APPLICATION No: P21/S3961/CM, (MW.0115/21)

Technical Note

PROJECT: Whitecross Farm PROJECT REF: EVY0927
Subject Response to EA letter Revision B

Figure 1: Wallingford Bridge arrangement on the 10m grid, showing zln_check for the raised embankment, 1d_nwk layer with green arrows for the conduits under the embankment, 2d_bc layer with red circles for SX links and corresponding 1d_to_2d_check with red cells

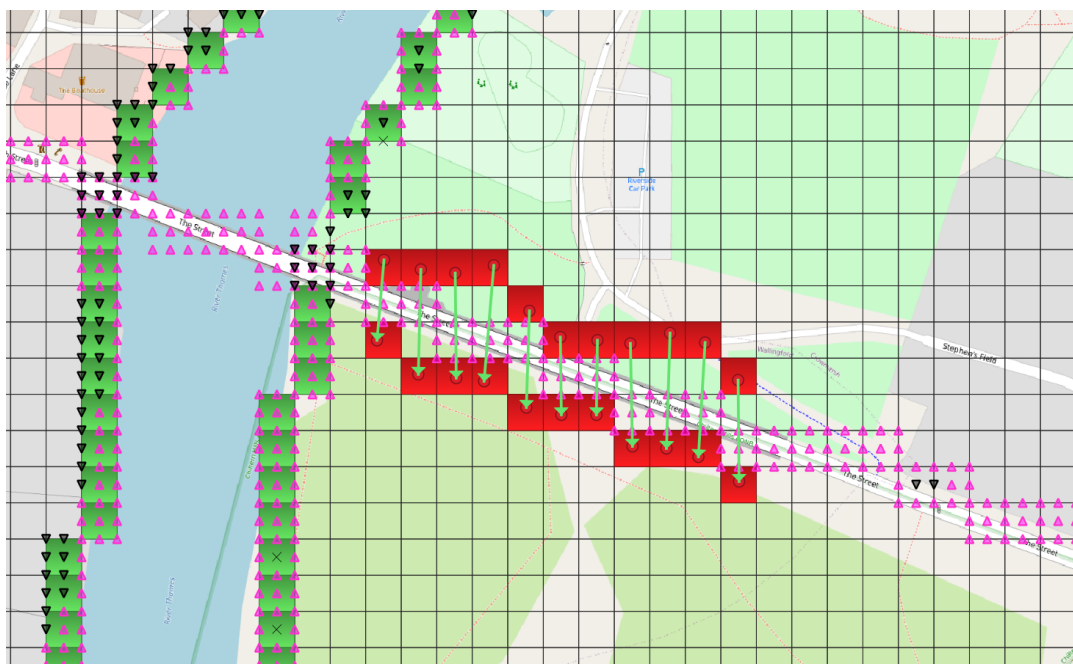
It should be noted that increasing the cell size to 20m resulted in a change in the position of cells selected to represent the road embankments and cells selected as SX links for conduits under embankments. At some locations the cell selected to be a boundary was the same cell as had been raised by a thick z-line and this was not appropriate for connection with an SX link.

As such, boundary features were moved to the nearest neighbouring cell to ensure connectivity on the floodplain. At Wallingford bridge, which is the closest such case, to the development site, the SX link circles for the 20m grid were moved to ensure that they did not select the same cell as the 2d_zln for the road embankment and the addition of CN lines to connect the pipes layer (unchanged) to the adjusted SX boundaries (see Figure 1 and Figure 2).

Figure 4: Flood Extent - 100cc12 event using version 7.4 with the 10m grid.

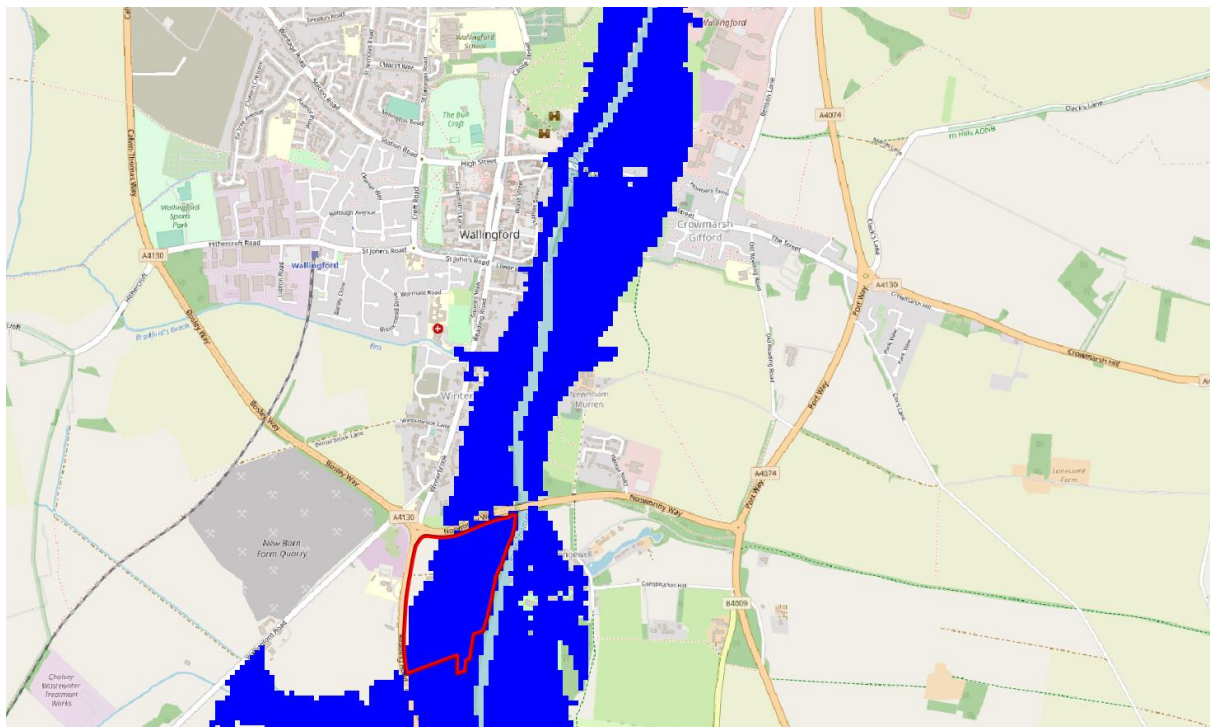
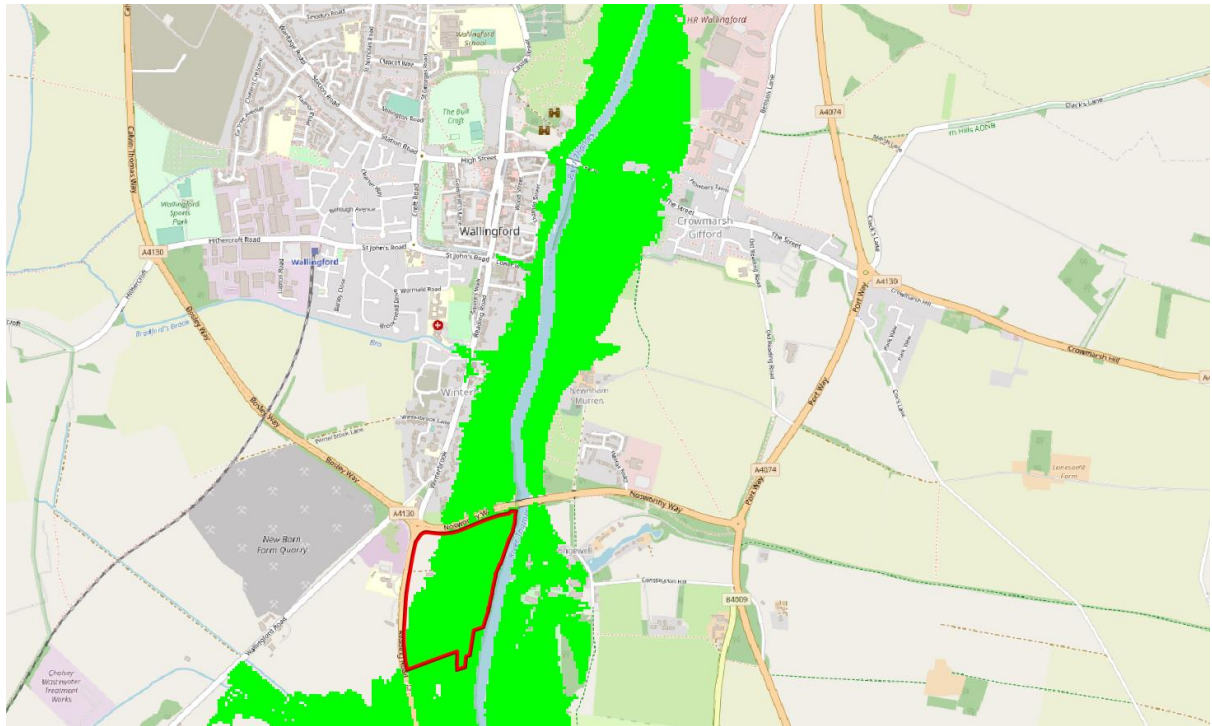
The Abingdon Flood Schemes River Thames model supplied by the EA was based on a 10m resolution. In order to determine whether a 20m grid resolution had a significant impact on the results, a sensitivity analysis was undertaken. Model version 7.4 is a duplicate of Model Version 7.3 (described above) except that the .tgc was adjusted to use a 10m cell size instead of 20m.

Figure 3 and Figure 4 show the outlines of the baseline flood extent with 10 and 20m grid sizes for comparison. The difference between the flood extent for the 10m and 20m grids is minimal. This is unsurprising as both versions of the model have mass balance errors less than 1%. As noted in previous correspondence, a mass balance error of less than 1% is generally accepted by the industry as an indication that a TUFLOW model is healthy.

Whilst both model versions are healthy, the small differences in flood extent are directly attributable to mass balance errors. Mass balance was discussed in detail in Edenvale Young' letter of the 1 March 2023 which demonstrated that the use of a 20m grid was more stable than a 10m grid resulting in smaller mass balance errors. Accordingly, the 20m grid (**model version 7.4**) has been retained as being appropriate in evaluating the difference in flood levels associated with the baseline and excavation scenarios. The full set of model files for Model Version 7.4 of the model have been made available to the EA.

Figure 5: Flood Extent - 100cc12 event using version 7.3 with the raster elevation contained in the supplied EA model

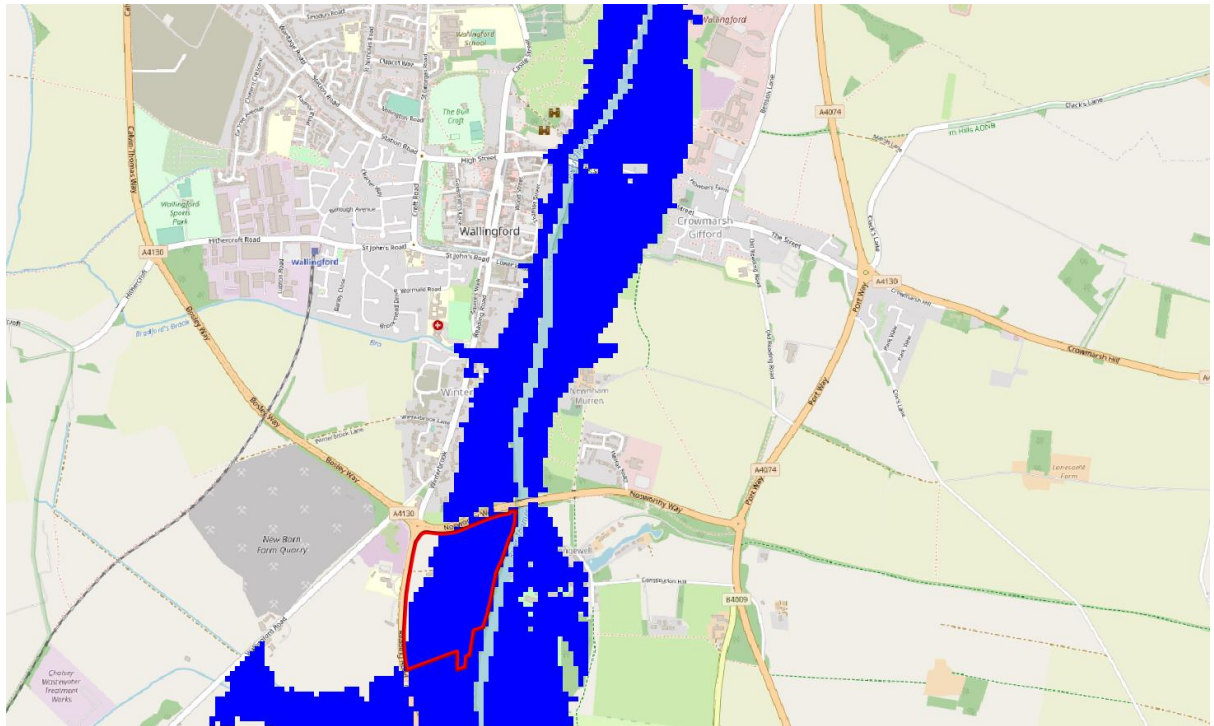
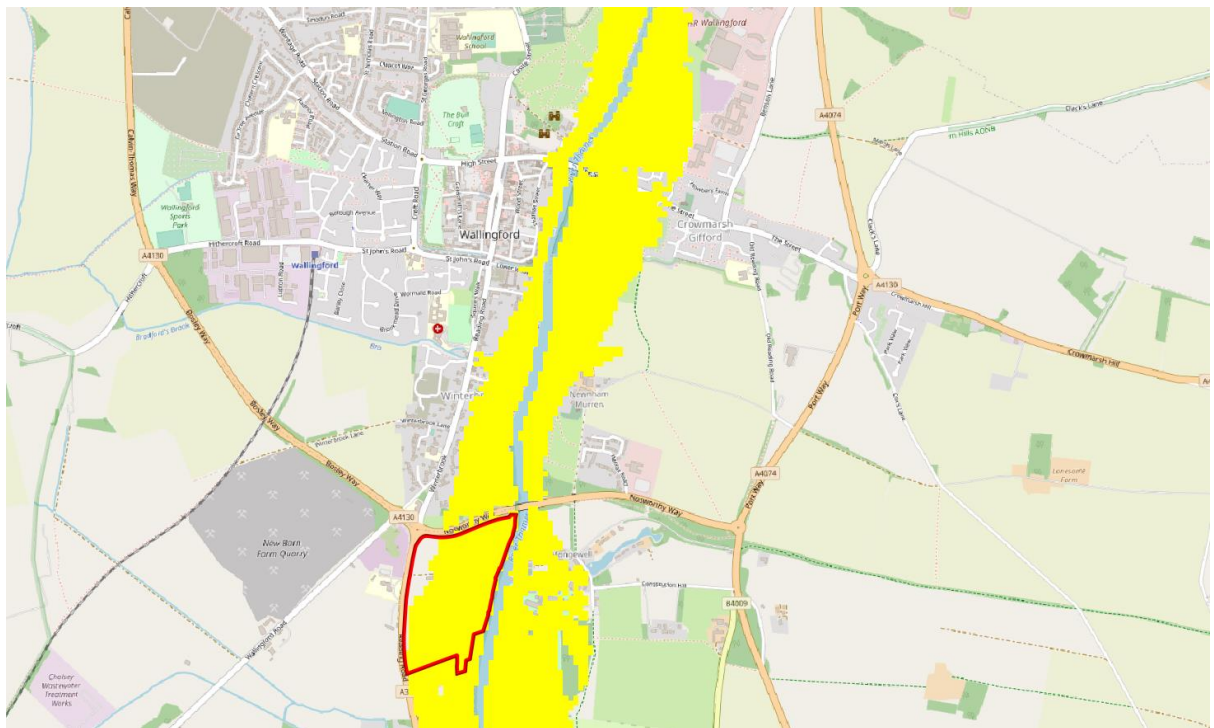
The model supplied by the EA incorporated raster elevations which are assumed to have been derived from an older LiDAR dataset. At the request of the EA a sensitivity analysis was undertaken to compare the results of the incoming model containing the embedded terrain data with the modified model containing new LiDAR. **Model version 7.5** is a duplicate of version 7.3. The .tgc was adjusted to include the latest composite LiDAR dataset (1m dated 2020) which was downloaded in February 2023 from DEFRA portal.

Figure 5 and Figure 6 show the baseline flood extent for comparison. The flood extents are very similar except in the area to the south-west of the site. A road crossing a tributary of the Thames, has been “filtered out” in the Abingdon Flood Schemes River Thames version of the model supplied by the EA. This allows flood water to flow into an area of low-lying land. This is not the case with model version 7.5. Such features are not unexpected when changing LiDAR sets, however they do require some consideration to ensure that a new LiDAR set is handled appropriately.

The use of LiDAR datasets was also discussed in detail in Edenvale Young’ letter of the 1 March 2023 which demonstrated that there is very little difference in the application of the old or updated LiDAR in relation to the mass balance error using a 20m grid. Given the broad agreement between the two sets of results it was not considered a beneficial use of time to update the model with new LiDAR. The full set of model files for version 7.5 of the model has been made available to the EA.
